Re: Rochester / VT-VT-0111A - Clarification Regarding Figures 1 and 2 – Site Location Mapping Correction

EBC Project No.: 001994-PR

Date: January 21, 2026

Natural Resources Review

Figure 1 - Street Map

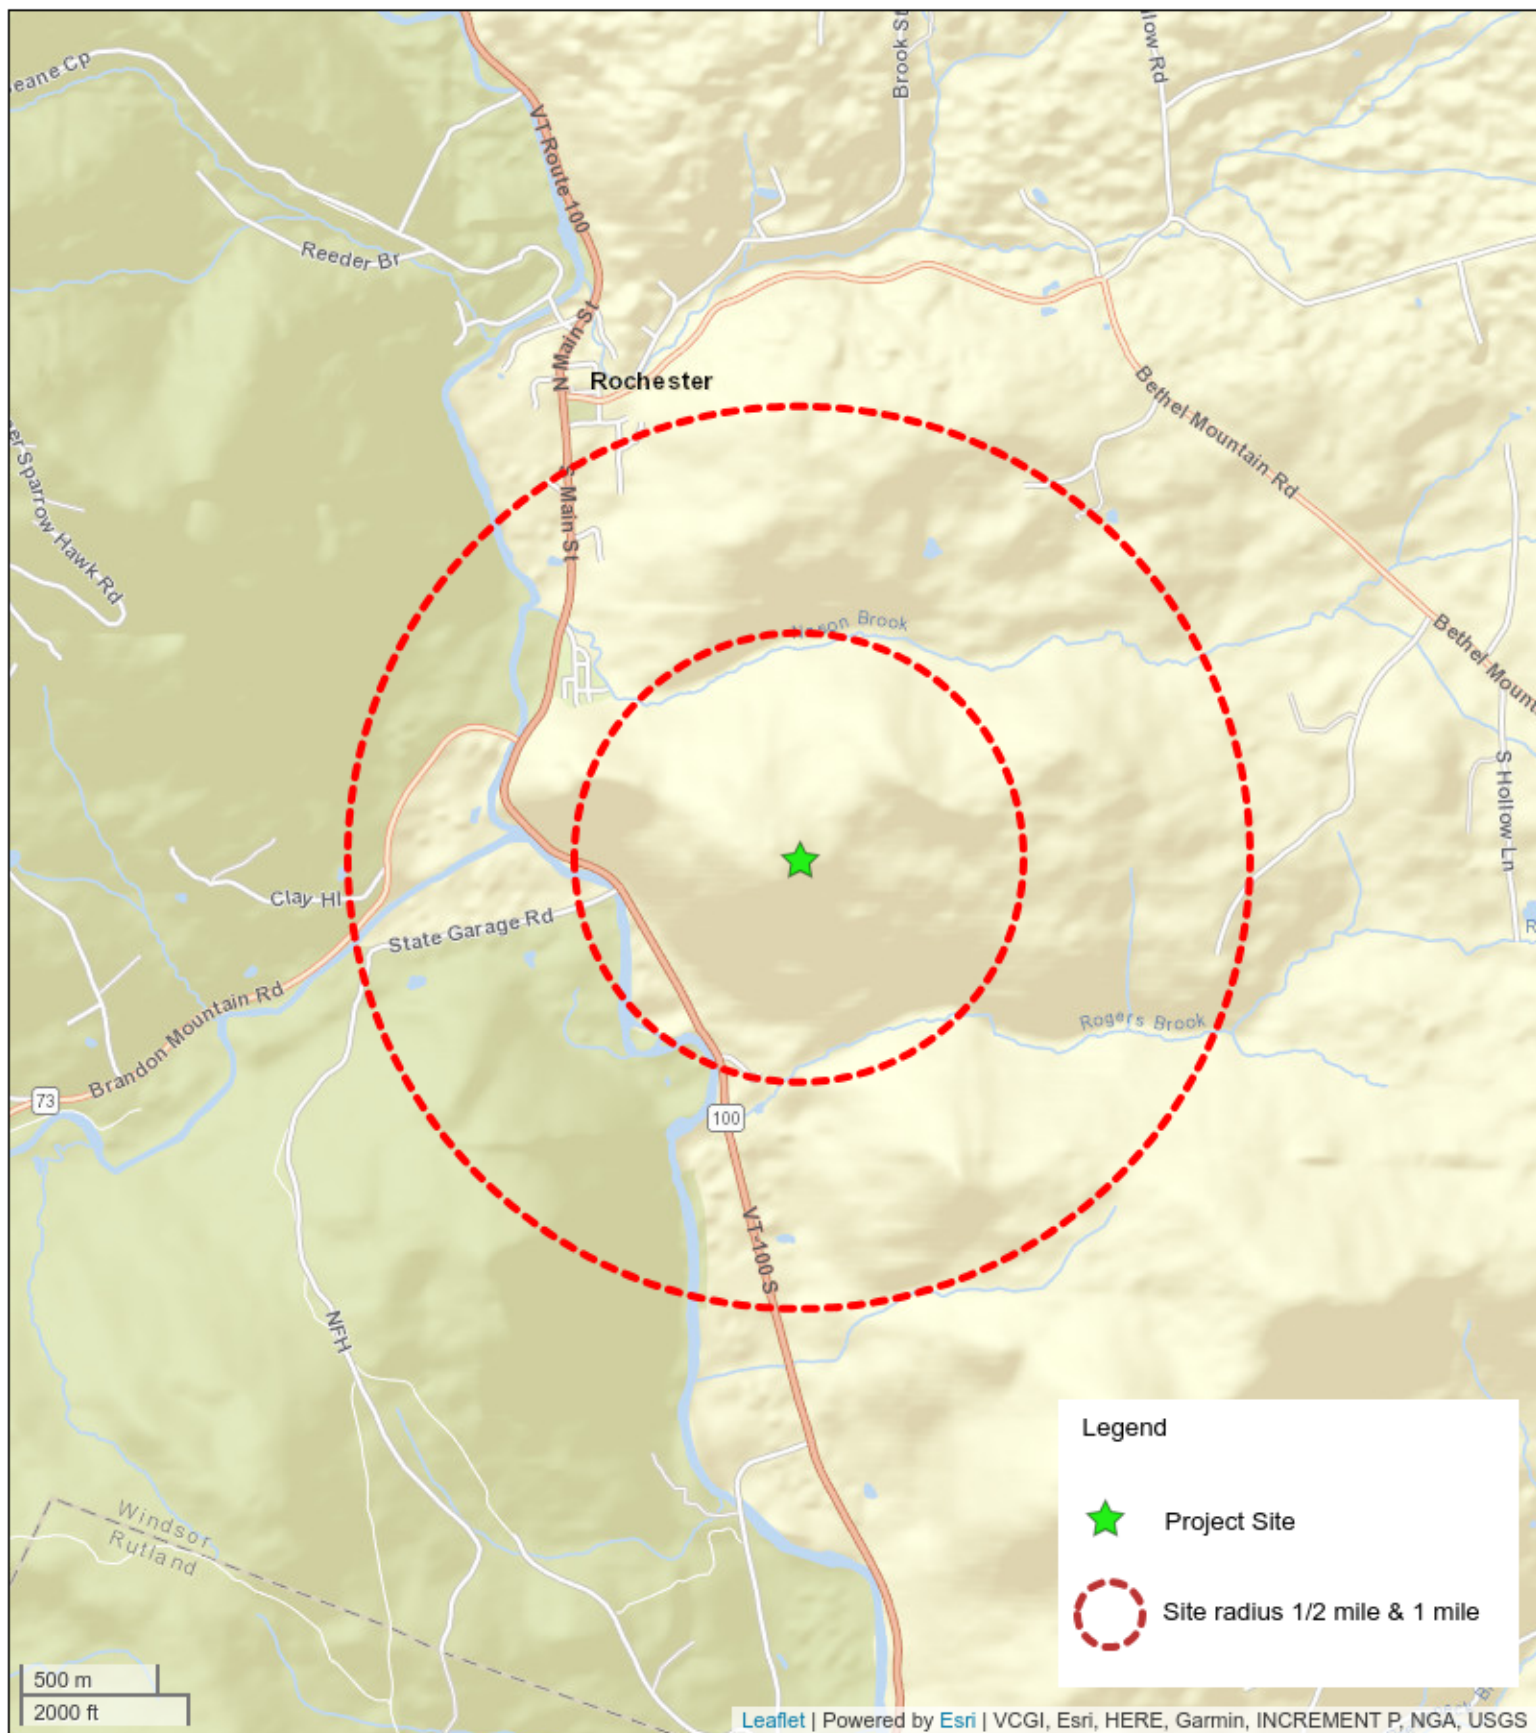
Figures 1 and 2 (located on pages 14 and 15 of the original report) inadvertently depicted an incorrect site location. This error was limited solely to the graphic representation shown in those figures and does not reflect the location that was evaluated during EBC's original natural resources assessment.

The report has now been updated to correct Figures 1 and 2 so that they accurately depict the evaluated project site location. This letter is provided for clarification and to document the correction.
